# VEC spec for 50GAUI-1 C2M and 100GAUI-2 C2M

Piers Dawe

# P802.3cd Draft 2.2 comment 30

# What the spec allows

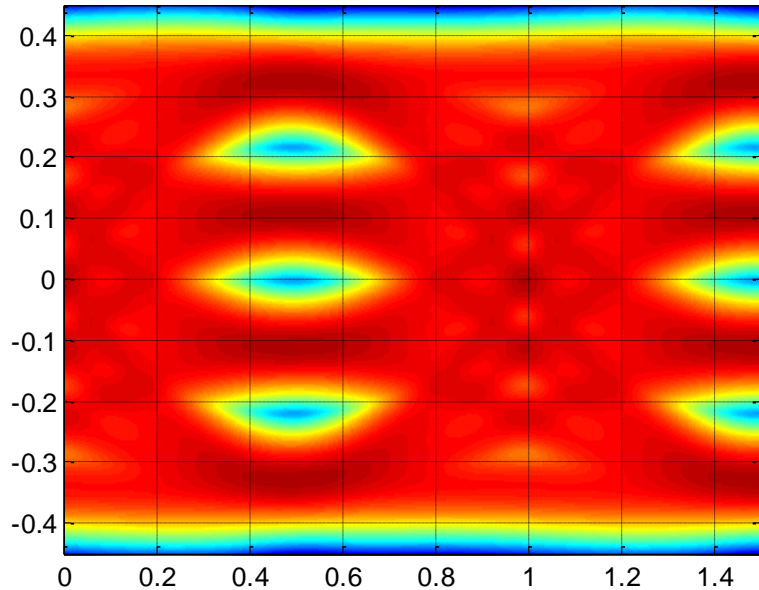
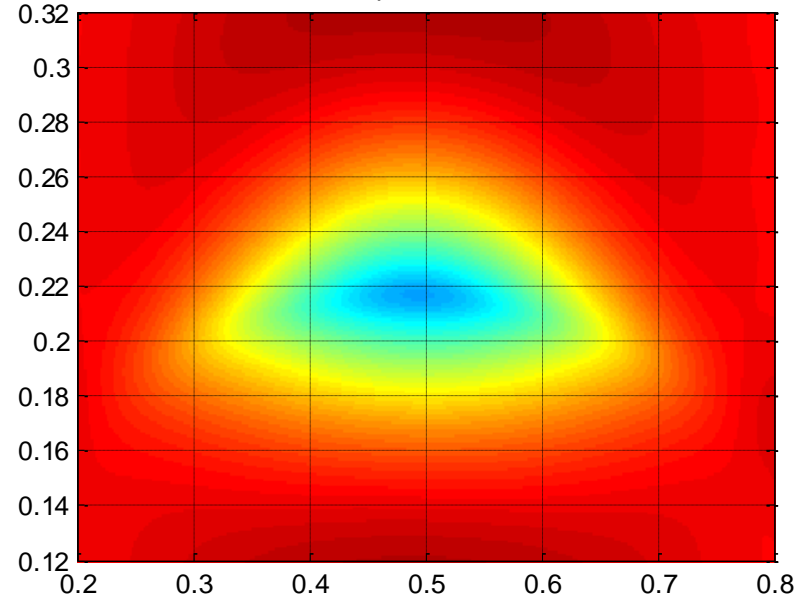
- This output from a low loss host is allowed by the spec. The signal is more than 2.5x bigger (0.83 V pk-pk vs. 0.31 V after CTLE) but the eye height (usable opening) is still only 35 mV for eye width at minimum. This signal's **VEC is 15.8 dB**.
  - It was hoped that the eye width spec would enforce a better eye height. But it doesn't do so significantly – a host could have less UBJ and more noise than this one, taking the eye height closer to the minimum 32 mV

- The module stressed input signals (slides 4, 7) have VEC around **8 dB**
- The bigger, blurry, but still near minimum height, eye (slide 5) has a VEC about **16 dB**
- A low loss host might have a worse VEC than a high loss host, but not 8 dB worse
- **Limit the host output VEC to 12 dB**
  - There is no need to do the same for the module output because the signal swing is limited before the host loss and the minimum eye height is enforced both before and after it
  - Use VEC rather than  $V_{pkpk}$  / eye height because we know how to specify and measure it
    - See P802.3bs D2.0 120E.4.2.1 Vertical eye closure
    - This was removed for D2.1 because it was not needed for the module output as well as the far end eye spec (D2.0 comment 173)
- This change could be made in P802.3cd sponsor ballot

# What the spec would allow – 14 dB

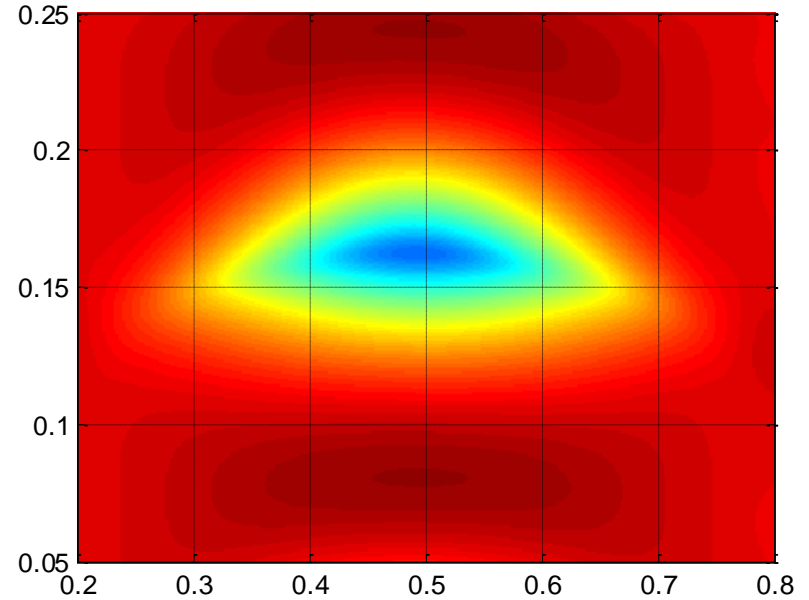
- This signal 0.67 V pk-pk after CTLE
- **VEC is 13.8 dB**
- Eye height is 33 mV

# What the spec would allow – 12 dB

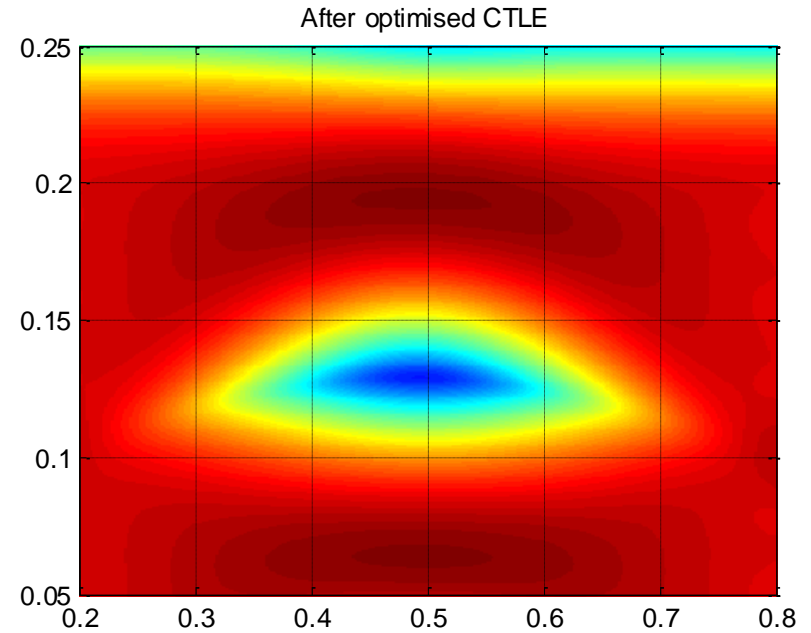
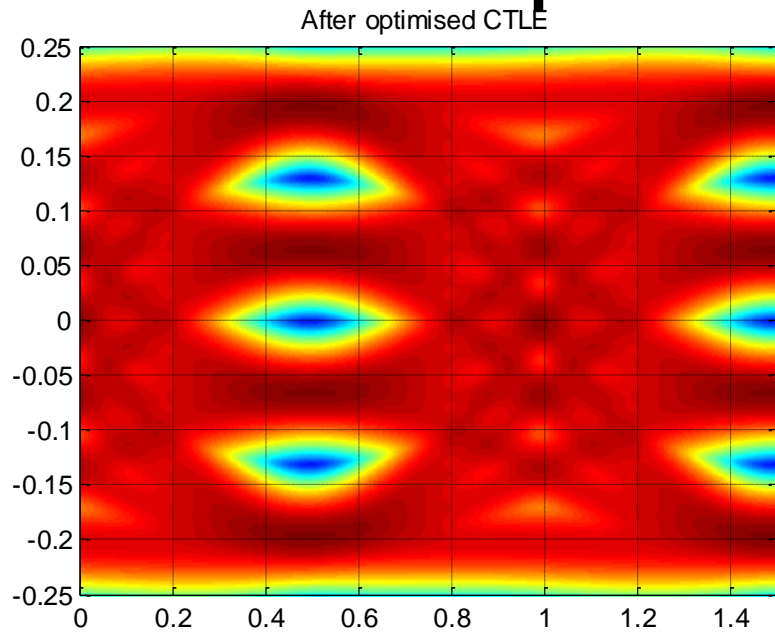
- This signal 0.49 V pk-pk after CTLE
- **VEC is 12.0 dB**
- Eye height is 32.6 mV

# Figure showing $AV_x$ used for calculating VEC

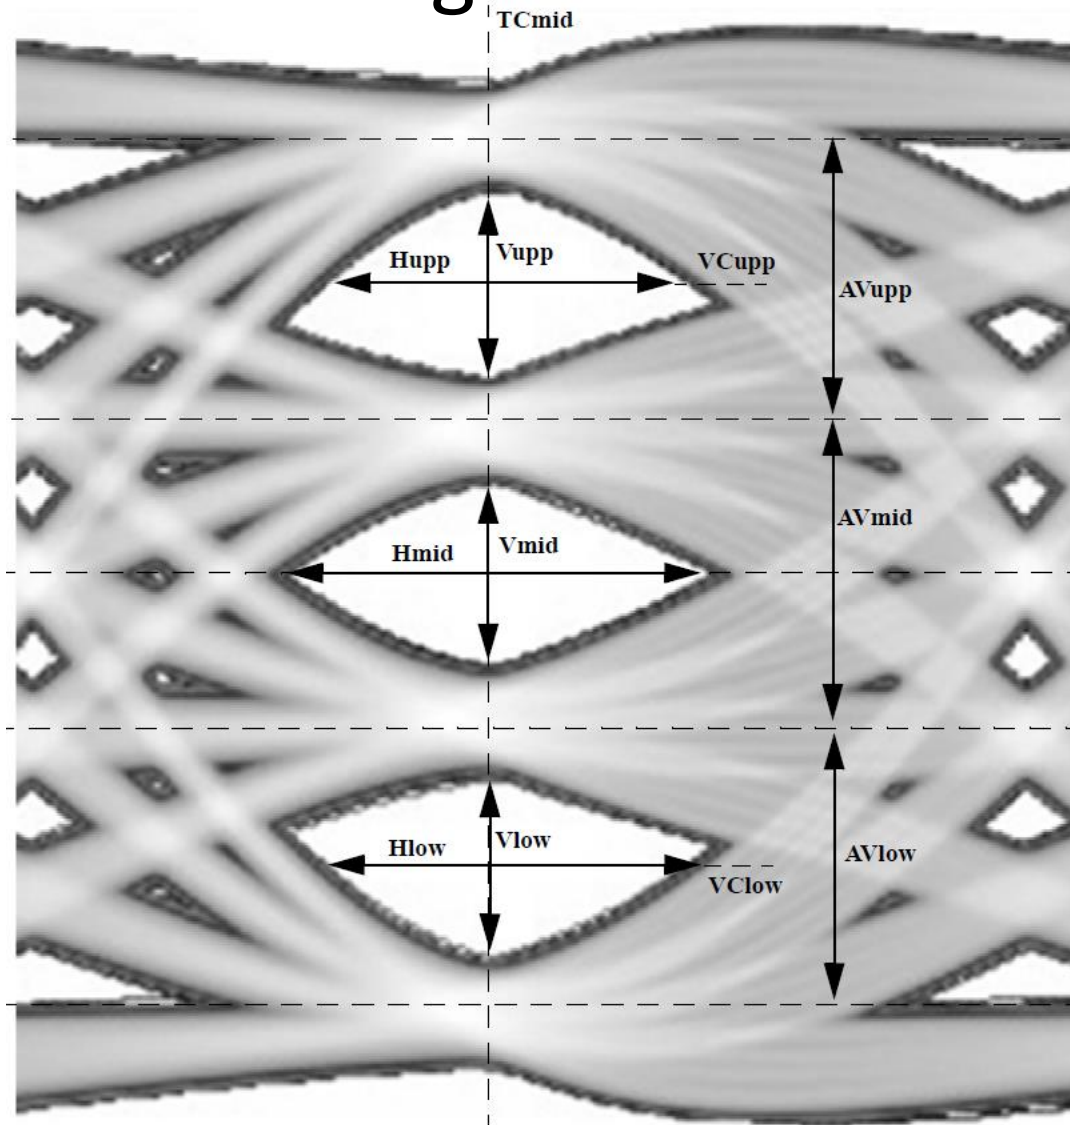
See example equation defining VEC on next slide

- Vertical eye closure is defined for the host output by Equation (135G–1).
- $VEC = 20\log_{10}(\max[Av_{upp}/V_{upp}, Av_{mid}/V_{mid}, Av_{low}/V_{low}])$  (135G–1)
